7243 NON-DRAIN BACK VALVE

This document serves as a quick guide to instruct the user on replacing 7143 non-drain back valve with 7243 unit. For further information visit www.Kobelt.com or scan the QR code below.

QUICK START INSERT

FIG.1-7143 vs 7243 OVERALL DEIMENSION

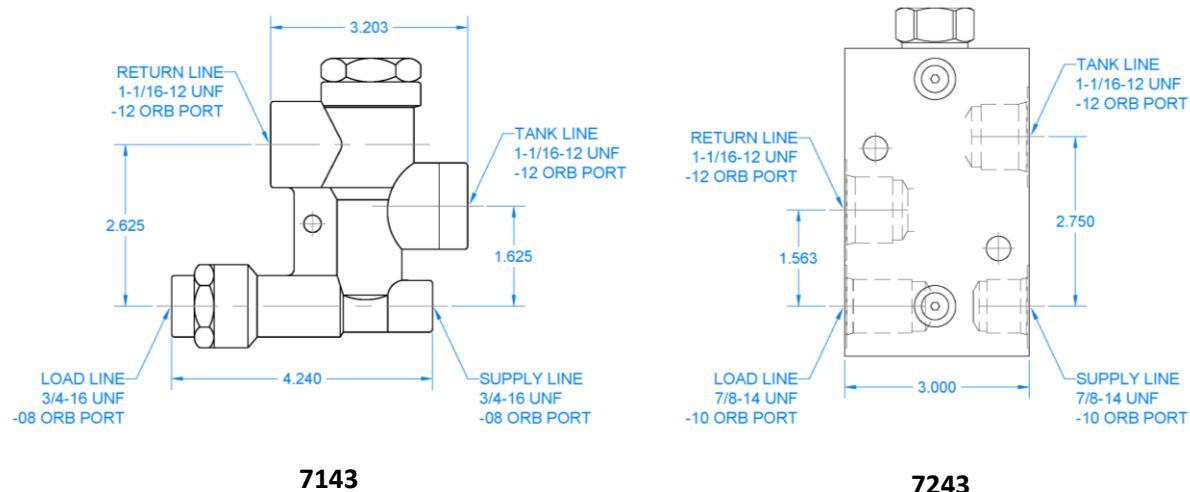
7243 has the same function as 7143, but port size and location are different as shown in Fig.1. *supply port* and *load port* changed from -08 ORB to -10 ORB.

1. Remove 7143
2. Cut all 4 line that connected to the unit to make room for fittings and hoses
3. Use flareless tube fittings on the tube side (Fig.2)
4. Use MORB to MJUC fittings on manifold (Fig.3)
5. Connect each line to related port with flexible hose
